Title - Sujet Palace Grand Theatre Foundation Rep	
Solicitation No. - N° de l'invitation EZ899-152418/A	Amendment No. - N° modif. 002
Client Reference No. - N° de référence du client	Date 2015-06-17
GETS Reference No. - N° de référence de SEAG PW-\$PWY-022-7522	
File No. - N° de dossier PWY-5-38030 (022)	CCC No./N° CCC - FMS No./N° VME
Solicitation Closes - L'invitation prend fin at - à 02:00 PM on - le 2015-06-30	
F.O.B. - F.A.B. Plant-Usine: <input type="checkbox"/> Destination: <input checked="" type="checkbox"/> Other-Autre: <input type="checkbox"/>	
Address Enquiries to: - Adresser toutes questions à: Arthur (PWY), Carolyn	Buyer Id - Id de l'acheteur pwy022
Telephone No. - N° de téléphone (604) 775-6667 ()	FAX No. - N° de FAX (604) 775-6633
Destination - of Goods, Services, and Construction: Destination - des biens, services et construction: Parks Canada - Palace Grand Theatre - Dawson City, YT

Amendment 002

BID DOCUMENTS FOR
PALACE GRAND THEATRE FOUNDATION REPLACEMENT

ADDENDUM No. 1
Jun 15, 2015

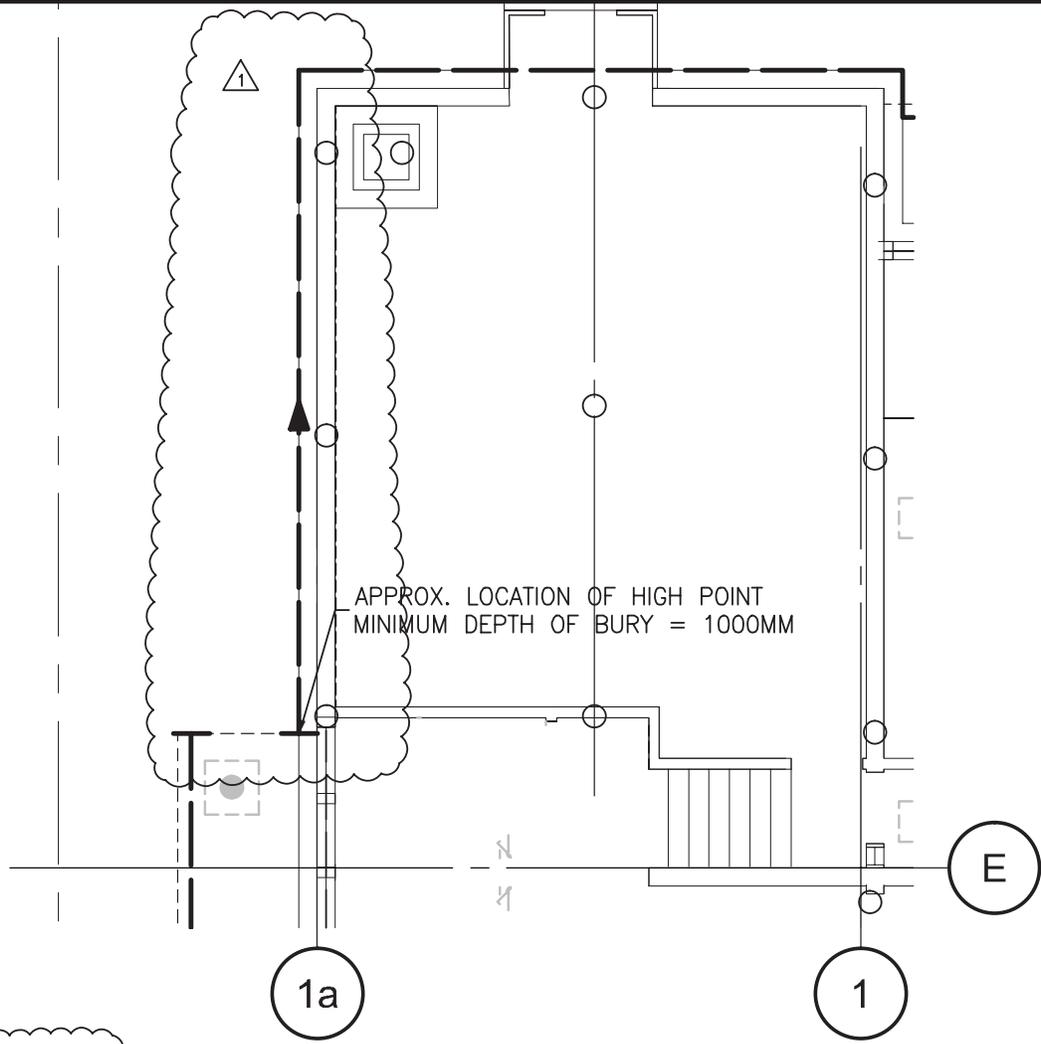
1. Refer to Tender Specifications
 - 1.1. Section 20 05 01 and 21 13 16: Revise all references to the word "engineer" to read "departmental representative".
2. Refer to Tender Drawings
 - 2.1. Reference drawings M1 and M2 and attached sketches SK-M01 and SK-M02.
 - 2.1.1. Dwg M1: Revise layout of drainage tile as shown on sketch SK-M01. Tile to be graded at 2%.
 - 2.1.2. Dwg M2: Change size of incoming water service from 4inch to 6inch.
3. Attachments:
 - 3.1. SK-M01, Rev 1: Revisions to Foundation Subdrainage Plan. 1 pg @ 8.5x11
 - 3.2. SK-M02, Rev 1: Revisions to typical Crawlspace sprinkler section. 1 pg @ 8.5x11

1. DRAIN TILE TO BE INSTALLED AT A **MINIMUM 2% SLOPE.**
2. CONFIRM LOCATION OF STORM WATER SUMP AND REVISE ROUTING OF NEW DRAIN TILE TO SUIT.

Keyless Light Fixtures and Receptacles in the crawl space

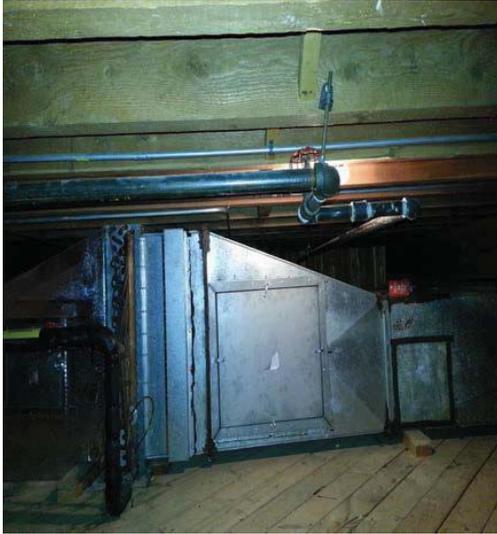
E7.	<p>Contractor to replace crawl space receptacles with new (new plugs and weather proof in-use covers), use same circuits and wiring. Allow for 20 plugs re-placements in the bid price.</p>
E8.	<p>Contractor to replace existing keyless lighting fixtures in the crawl space with new vapor tight fixtures, standard of acceptance: VXBRLLED13DG RCL complete with wire guard for complete operational lights. Allow for 20 light fixtures in the bid price.</p>
E9.	<p>General Note: most of the electrical devices in the building fed through the crawl space. In most of the areas the conduits and wiring required to be removed to allow for the civil work on the floor s and crawl space, contractor is encouraged to visit the site to familiarize himself with the scope. Allow for all work in the bid price for complete operational systems. All work must be coordinated with other trades.</p>
